TI 1098 - TD3030 locks

MACHINES AFFECTED: TD3030 from S/N 23300/002677 to S/N 23300/006352, inclusive.

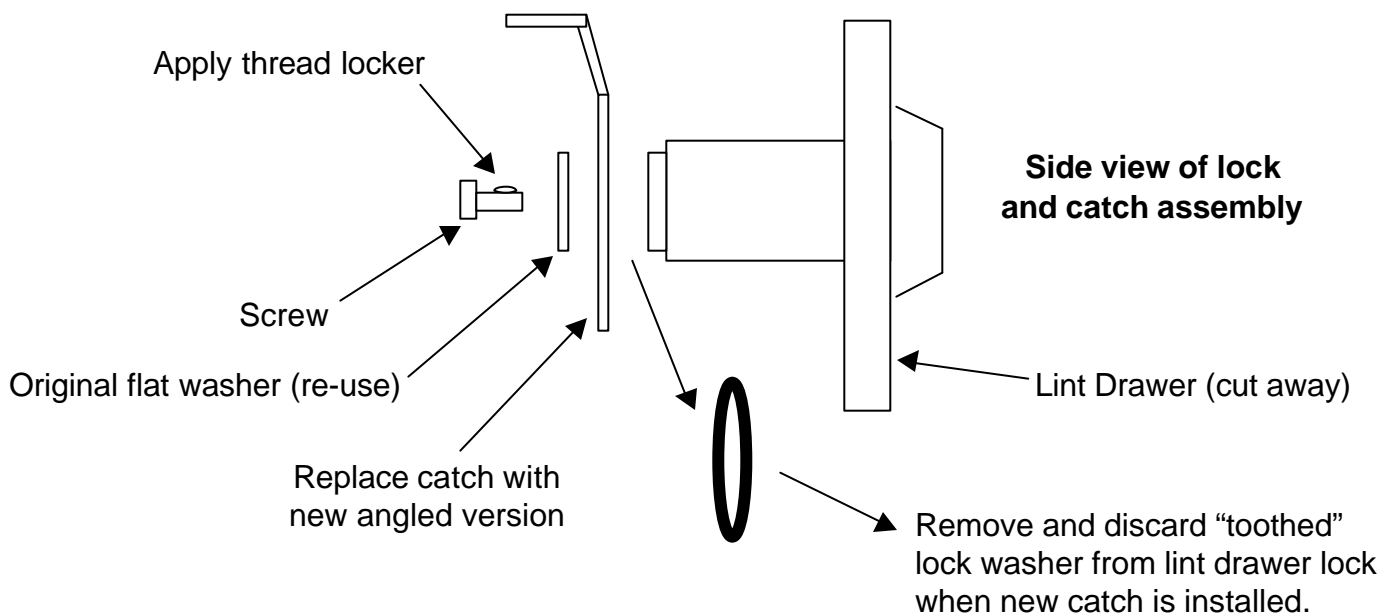
On TD3030 dryers from serial number 23300/002677 to 23300/006352, there is a tendency for the lock-catch retaining screw to loosen and fall out of the lint drawer (and possibly the control-panel) lock. When this occurs, the tumbler assembly may fall out of the front of the lock cylinder, and come apart, requiring replacement.

At the next service visit, it is recommended that the catch-retaining screw be removed, and re-installed using a small amount of thread-locking compound on the screw threads (Loctite 222 or equivalent). Use care to prevent the tumbler from falling out of the lock cylinder while the screw is removed.

If necessary, replace the complete lock assembly and catch, re-assembling the unit as shown. Note that the replacement catch for the lint drawer has a slight bend in it, and that the toothed lockwasher between the catch and the lock cylinder is to be removed from the assembly when the new catch is installed.
